PLANNED UNIT DEVELOPMENT AMENDMENT APPLICATION NO. 2

Verano South Pod G

City of Port St. Lucie Project No: 21-071

EXHIBIT C
LIST OF AMENDMENTS

PSLUSD #11-652-36
PSL PROJ# P21-071
LOCATION MAP

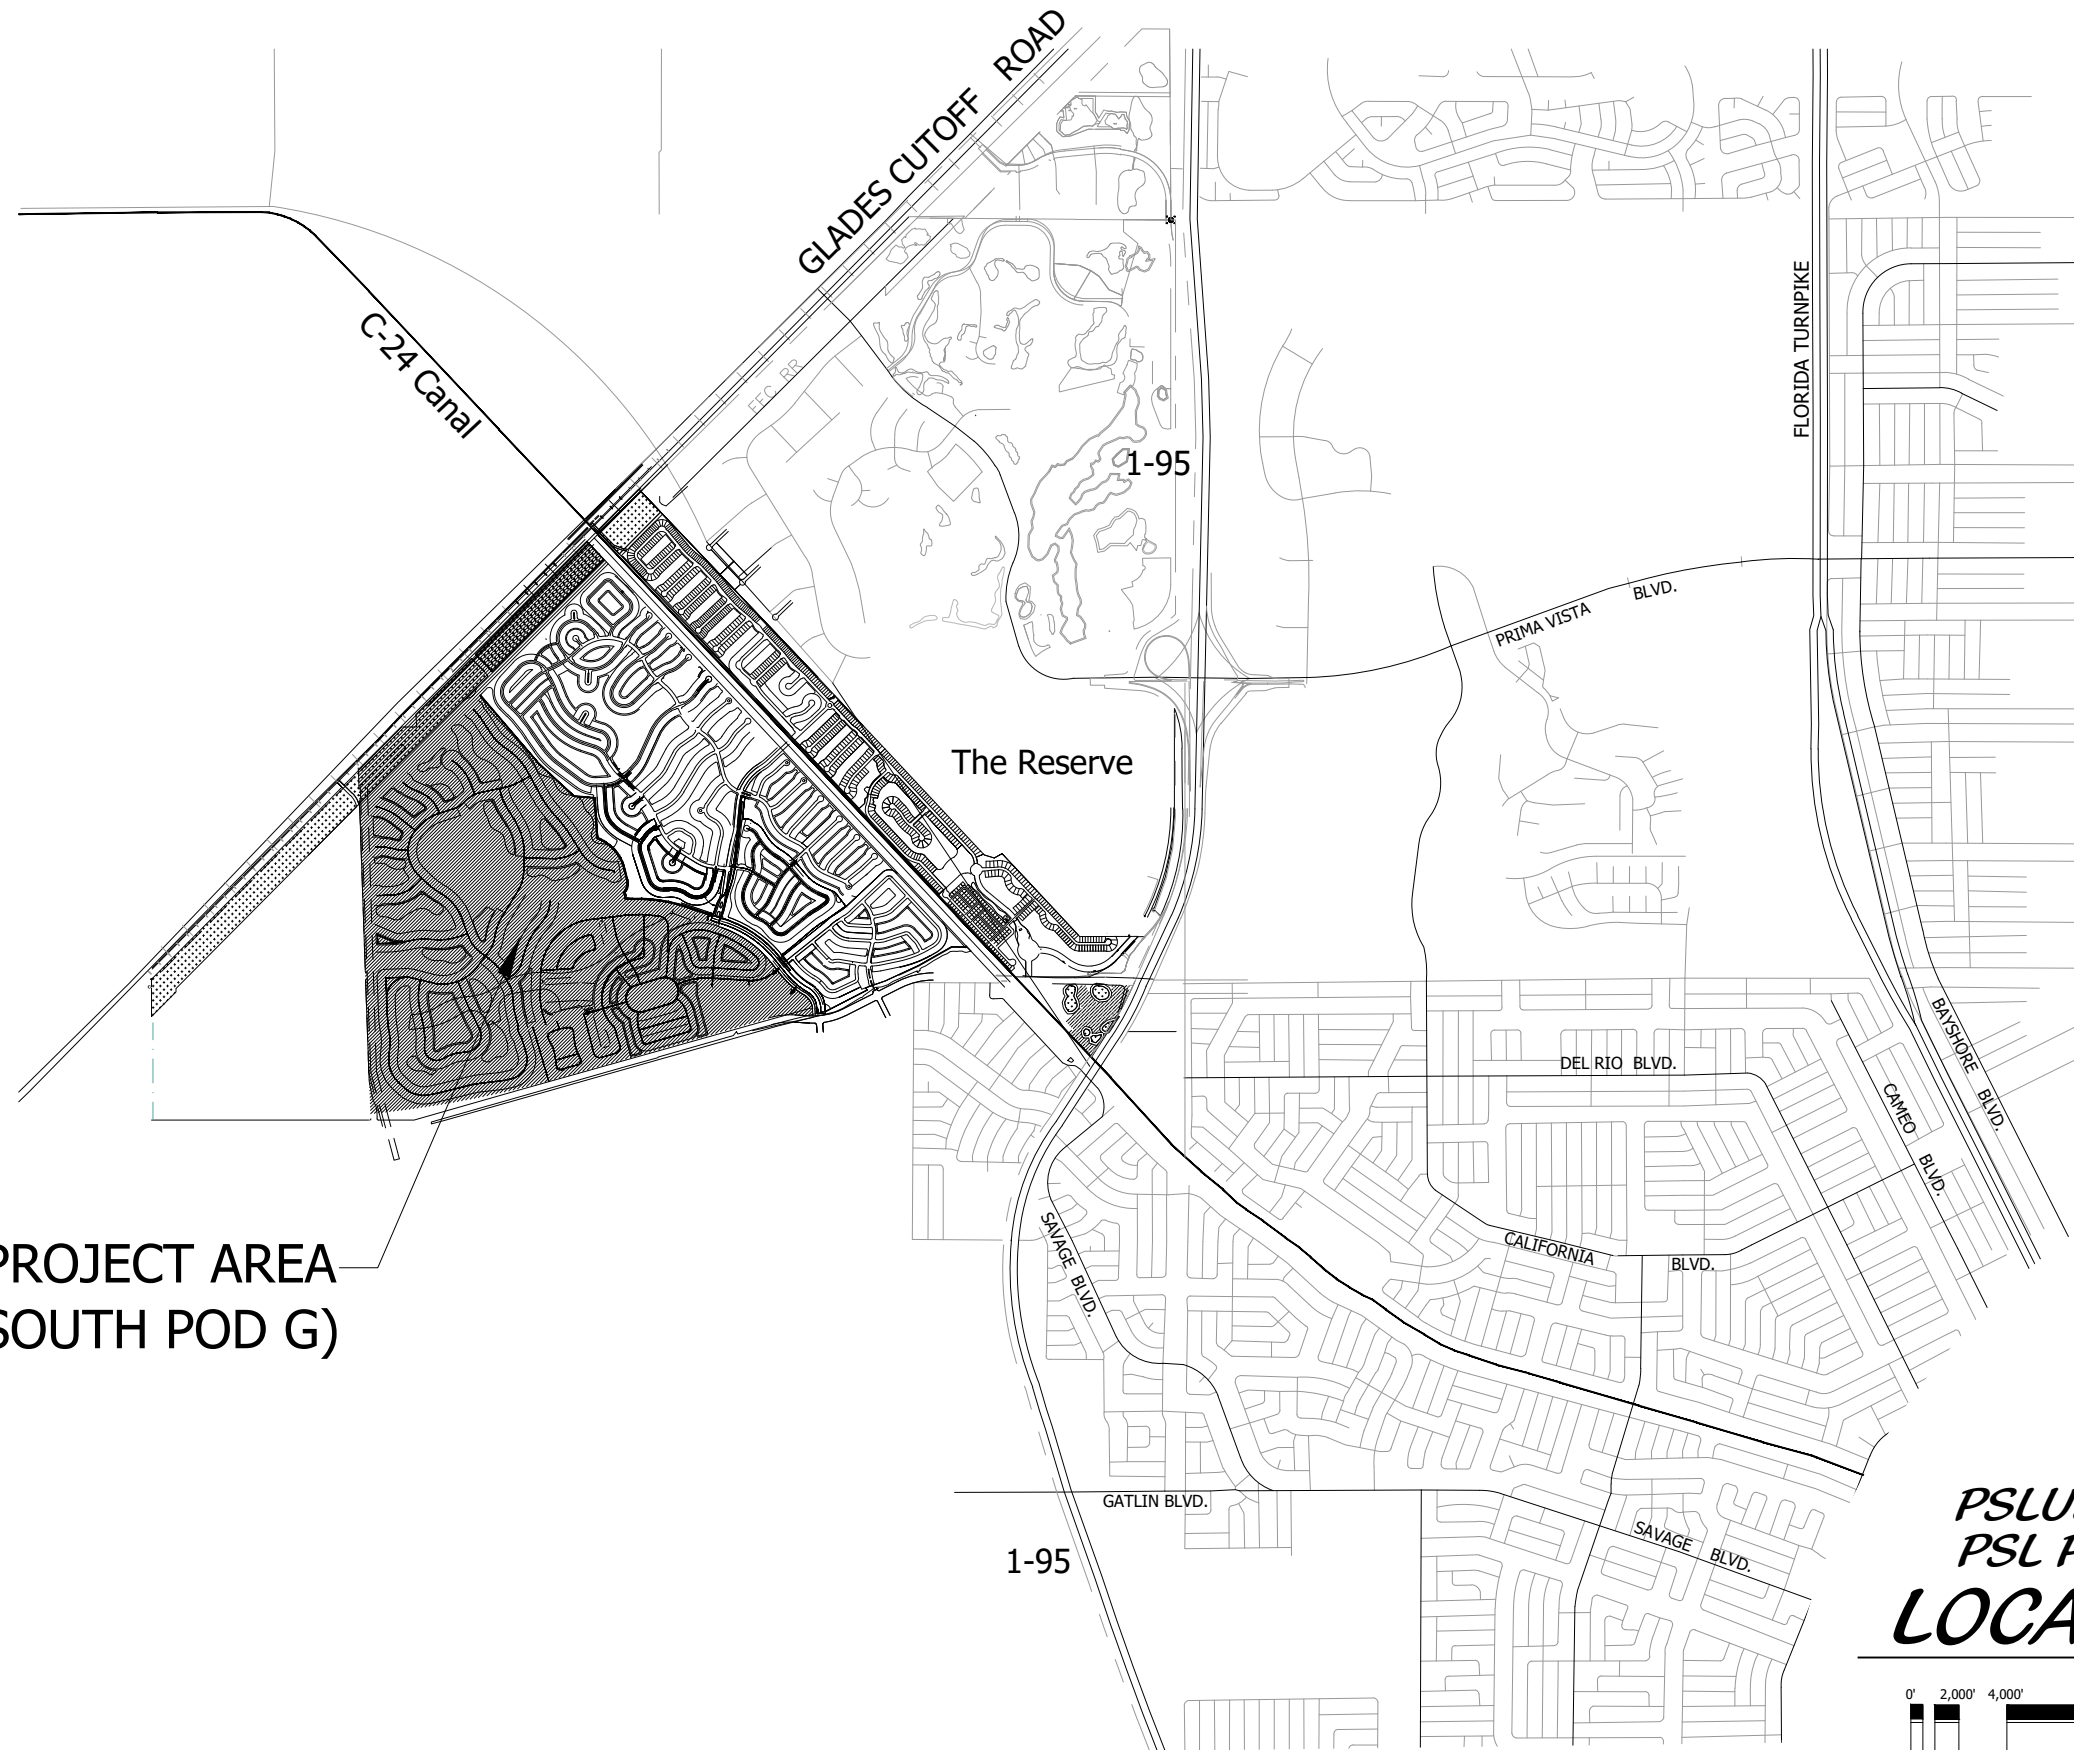
- Added revised Location Map showing revised POD G Boundary on page no. 58.
- Added revised PUD Conceptual Master Plan, Exhibit 9 (a) on page. 60
- Added revised Water and Sewer Conceptual Master Plan., Exhibit 9(b), Page no.62.

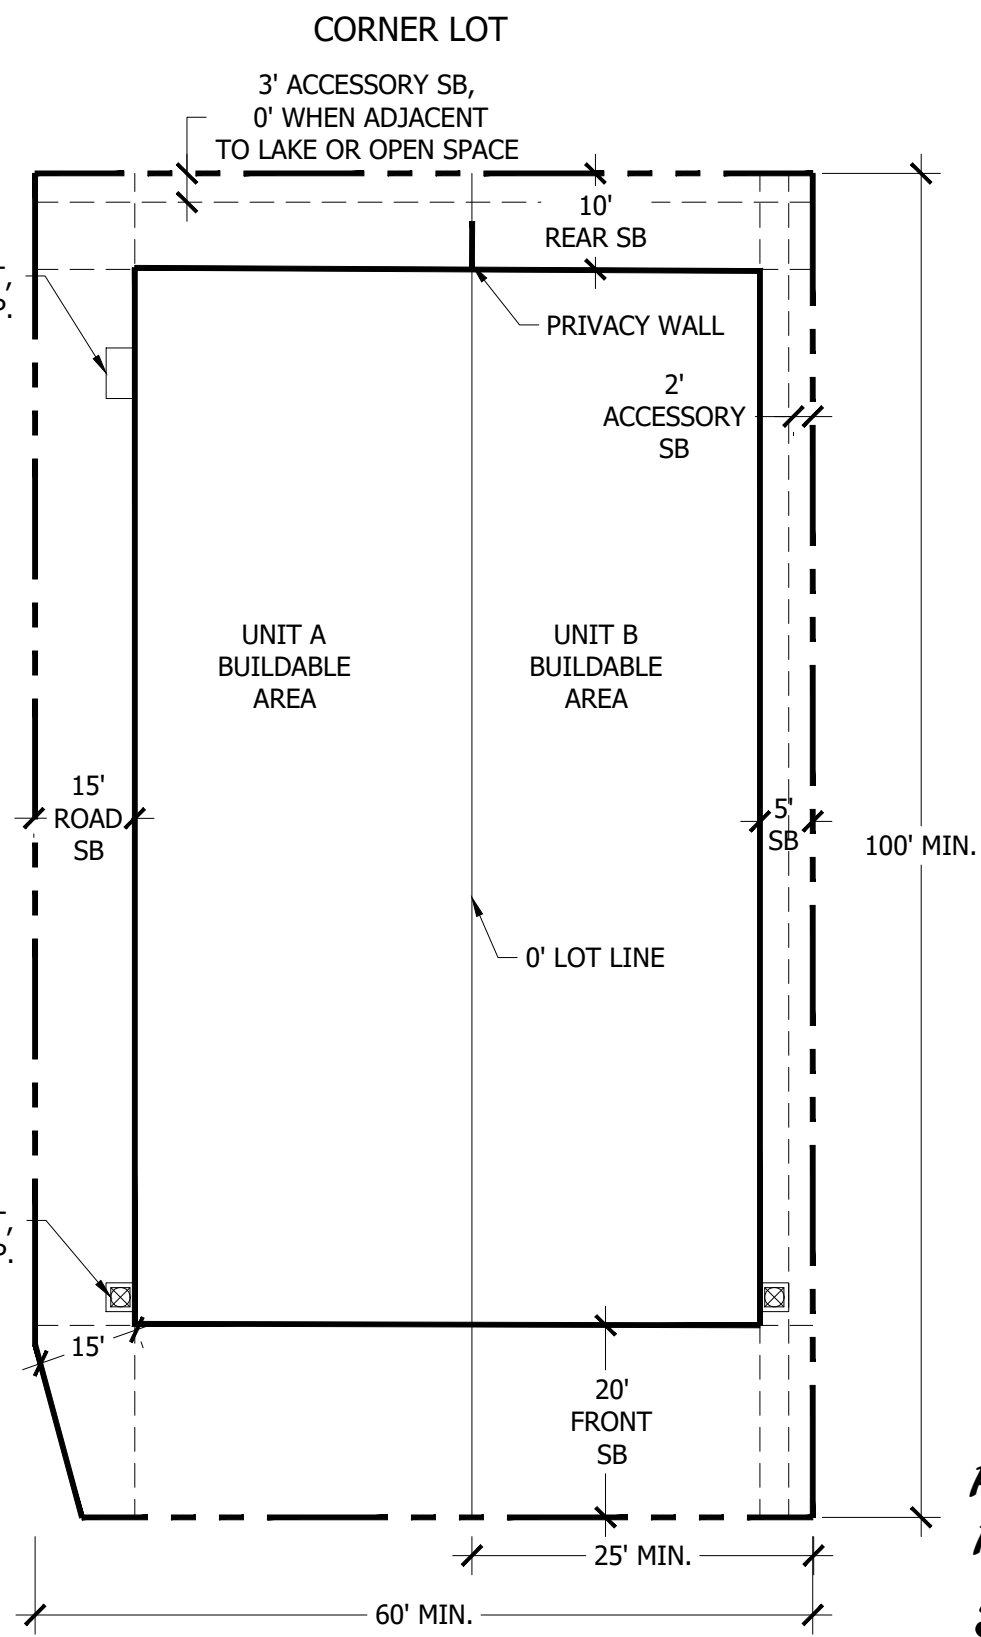
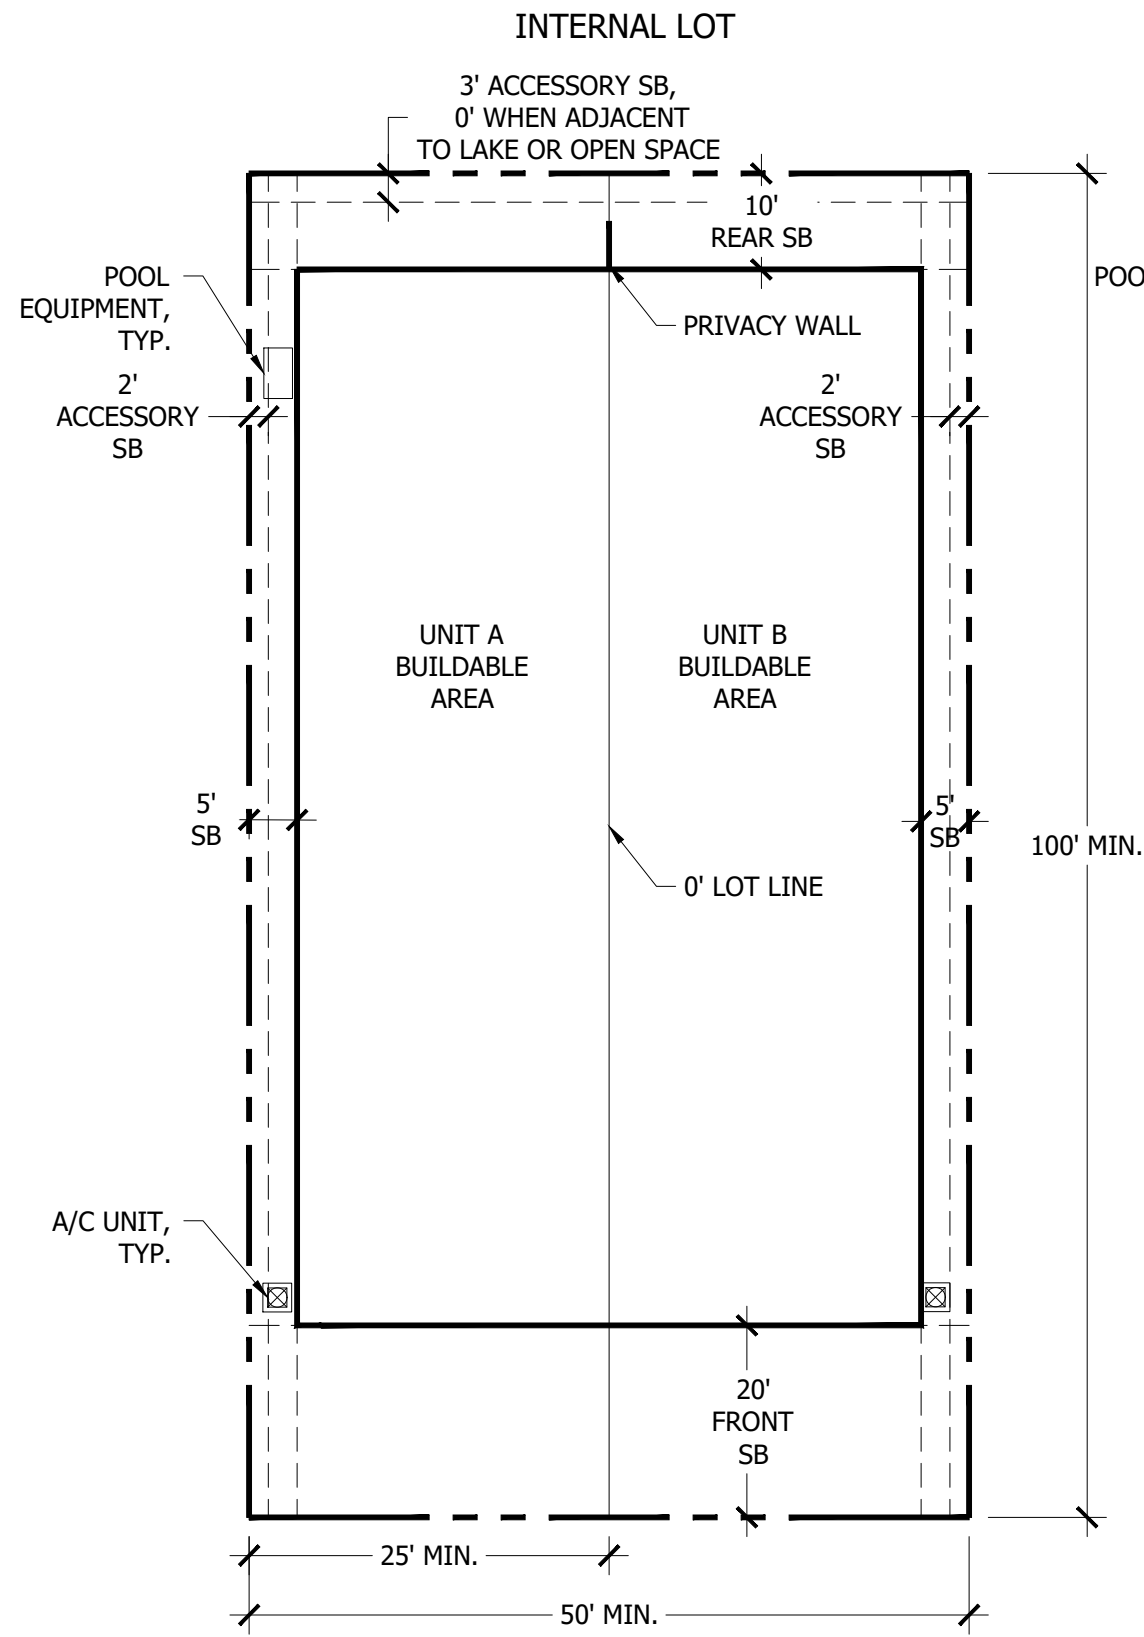
- Added 40' Right-of-way to exhibit 10, Page no. 64.
- Updated setbacks and lot width in Exhibit 11, (Pages 72-73) Typical Townhome Lot.
- Removed dashed line on the internal lot drawing, Exhibit 11, (Pages 72) Typical Townhome Lot.

- Revised minimum width of the driveway from 8' to 9' on Exhibit 11, Typical Lots (Pages.72-77).
- Minimum side setback has been updated to 15'from 10' on Exhibit 11, Typical Lots (Pages.72-77).

- Added minimum lot area for all the lots, (Pages.72-77).
- Updated Exhibit 12, Traffic Statement Page (80-81).

- Notes:**
1. ACCESSORY SETBACK IS 3' MIN. OR 0' IF ADJACENT TO OPEN SPACE OR LAKE.
 2. THERE WILL BE A 10' MIN. SEPARATION BETWEEN BUILDINGS
 3. THE MINIMUM WIDTH OF THE DRIVEWAY IS 9'.
 4. MINIMUM LOT AREA IS 2,500 SF.
